## **DIFFERENCES BETWEEN STARTER DRIVES ZEN 0294 AND 0328**

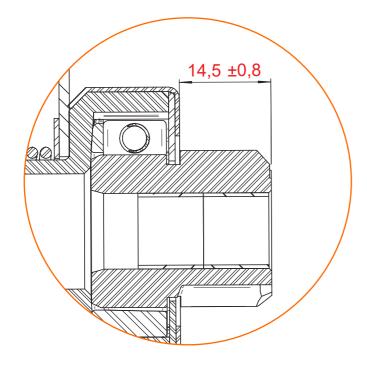
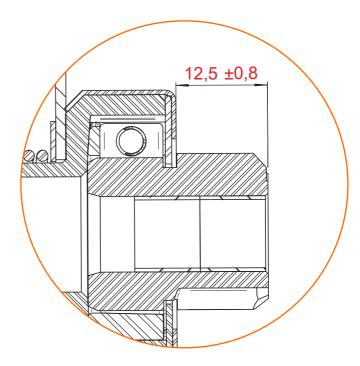
The part numbers 0294 and 0328 are almost identical, however the height of the gear is different, as shown in the image below.

• If the 0294 is applied in the place of 0328 there will be no problem.

• If the 0328 is applied in the place of the 0294 it may cause damage to the starter drive and/or the vehicle's flywheel

When in doubt apply the 0294.
